Docket Item #s 10 & 11
BAR CASE # 2009-0016 &
BAR CASE # 2009-0017

BAR Meeting
March 4, 2009

ISSUE: Addition and alterations and Waiver of HVAC Screening Requirement

LOCATION: 117 South Lee Street

Figure 8. Proposed demolition in plan.

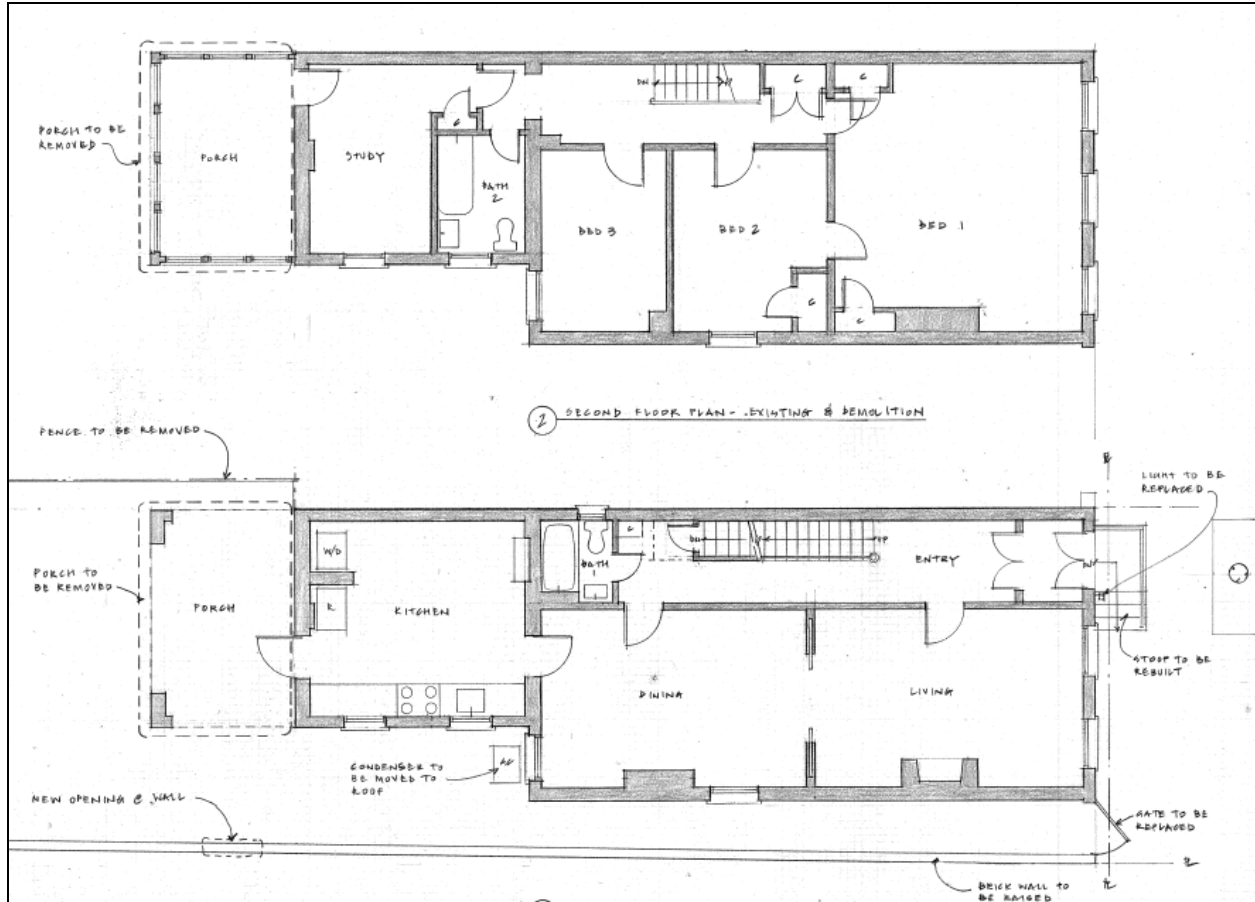
Regarding the demolition of the brick flue, the *Design Guidelines* indicate that “existing chimneys should be maintained *in situ* and not removed without a compelling reason and substantial justification.” The applicant has not provided a compelling reason for demolition of the chimney/flue. While the flue is not original to the building, Staff finds that it possibly is still considered historic (50 years or older) and should be retained as part of the evolution of the building.

The *Design Guidelines* pronounce that “an important visual feature of the historic districts are the fences, garden walls and gates that define property lines...[and] serve as a distinctive feature of the streetscape and individual yards.” Staff is very concerned regarding the proposed demolition and alterations of the historic garden wall on the alley (south) property line. In Staff’s opinion, the proposed additional height to the historic garden wall and the proposed piers are inappropriate. Adding 18” of brick to the existing wall not only erodes the historic integrity of the existing garden wall but also disrupts the distinct vantage points resulting from looking through alleyways from streets – a definitive characteristic of block porosity in the historic district. Furthermore, Staff finds that the new brick garden wall on the north and west property lines should be no higher than 6’ at grade at the property line. Specifically, Staff does not support the height of the new garden wall at 8.5’ on this property line. Section 7-802 of the Zoning Ordinance permits the BAR to waive the requirements of fence height as stated in the Zoning Ordinance “where to do so would be consistent with the historic character of the district.” The applicant has not presented a compelling argument as to why an 8.5’ garden wall at this location is consistent with the historic character of the district. Staff recommends restudy of this garden wall to step it down with existing grades along the property line.

Figure 9. Proposed elevations: front (east) and side (north).

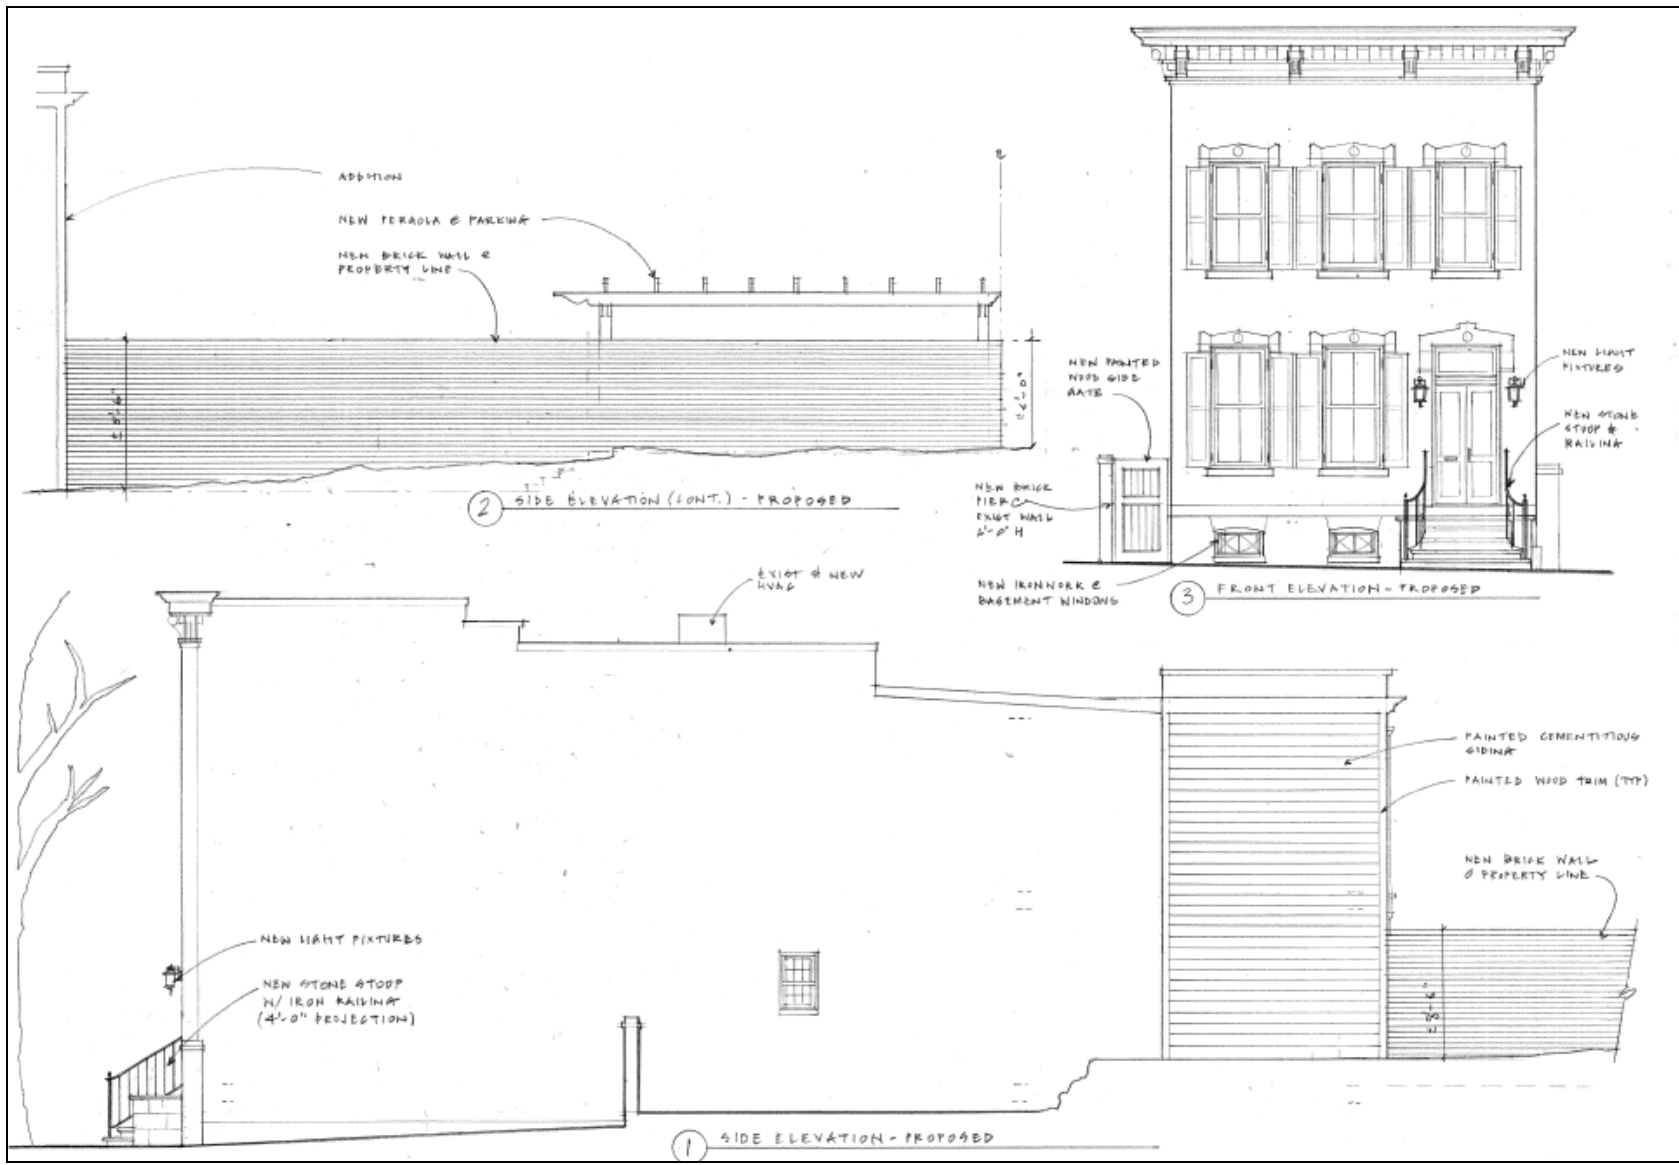
Staff has expressed concerns to the applicant regarding the height and massing of the proposed addition. Specifically, Staff finds that an addition should be no wider than the existing historic house (21' at the addition, 14.7' at the rear ell and 20' at the main block). While appropriate, and even encouraged, to differentiate new construction from historic fabric, Staff finds that the extension of the addition beyond the historic building's wall plane is inappropriate and overwhelms the existing structure. A more common form of differentiation would be offsetting the addition to have it step in from the historic house. Moreover, the addition is already appropriately differentiated from the historic house through the change of materials and shift in architectural vocabulary. Generally, additions should be subordinate to a historic building, specifically in regard to height. As proposed, the addition is approximately 2.5' higher than the rear of the house. The pronounced entablature on the addition likely will draw attention to the increased height of the addition. Staff has no objection to the proposed pergola adjacent to the rear ell and connecting the addition and main block and finds that it will not overwhelm the historic building and serves as a transitional element between the new construction and historic fabric.

While the use of true divided light wood windows and doors are preferred for the addition and consistent with the *Design Guidelines*, Staff recommends that a different light pattern be studied for the windows. The two-over-two windows, intended to relate to the two-over-two historic windows on the dwelling, have a slightly different proportion than what would typically be found on a classically detailed addition such as this. Staff recommends that other windows be considered before making a decision to continue with the two-over-two light pattern.

Regarding shutters, the *Design Guidelines* state that "decorative window and door shutters that are not operable are strongly discouraged" and that "shutters should be appropriate to the period of the structure." The use of fixed shutters in this manner is a unique design solution for the treatment of the solid wall space. Shutters are appropriate for an enclosed porch and represent traditional building patterns. While the use of inoperable shutters as proposed may ultimately be acceptable in this circumstance, Staff finds that this treatment should be further studied.

1. That the applicant restudy the height and massing of the proposed addition so that it fits within the wall plane of the historic building and is no taller than the portion of the historic house immediately adjacent;
2. That the applicant continue to study the proposed window and shutter scheme;
3. That the applicant eliminate any alterations or demolition to the historic garden wall on the south (alley) elevation and should reuse all historic brick on the altered garden wall located at the west (rear) property line;
4. That the applicant revise the new garden wall on the north property line to be no more than 6' in height from grade by stepping the wall down accordingly with existing grade; and,
5. That the applicant should continue to work with Staff in developing design details as they relate to the shed, addition and other alterations.

Figure 12. Proposed alterations to rear yard area including garden walls, pergola and shed.

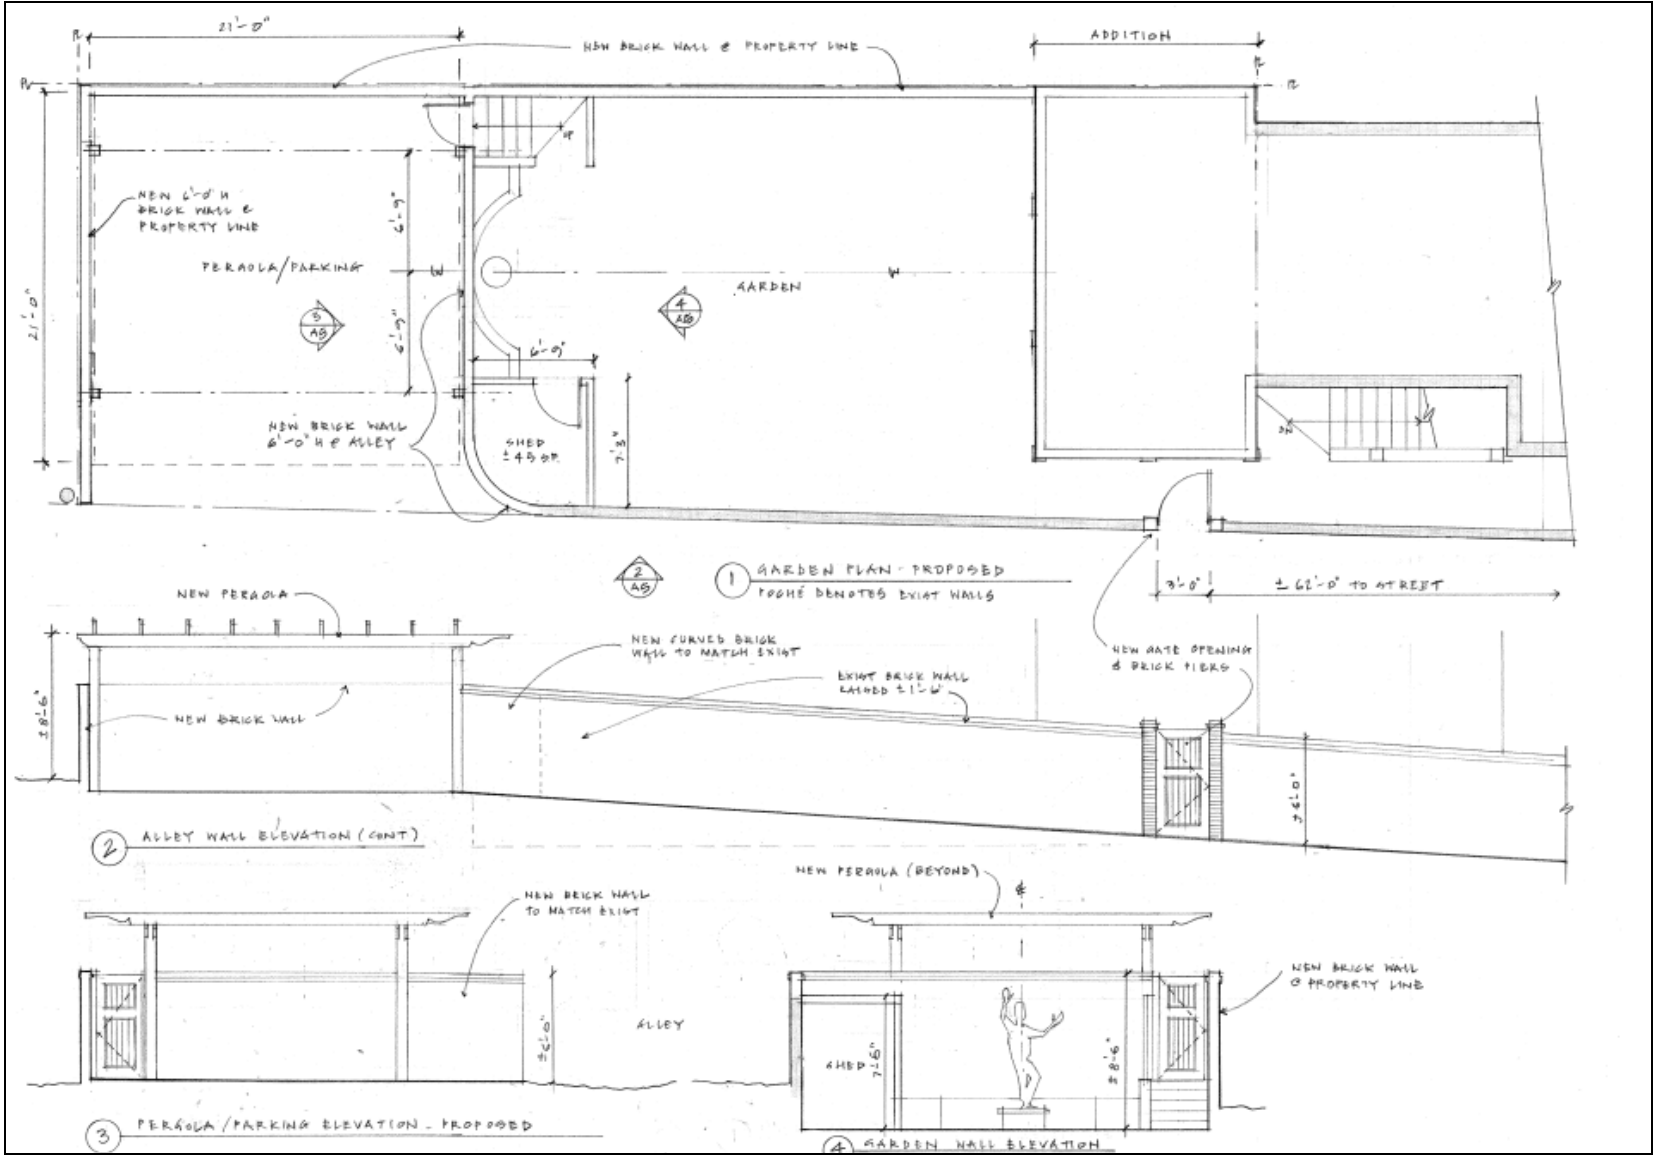
Staff finds the proposed pergola over the parking area to be appropriate in design, scale and materials. The proposed alterations to the garden area, including the shed, are generally appropriate. Due to the reduction in grade in the rear yard, the shed will be minimally visible. With the exception of the proposed new gate on the alley elevation, the proposed painted wood gates are appropriate. Staff recommends elimination of the gate on the alley elevation to minimize demolition of the historic wall.
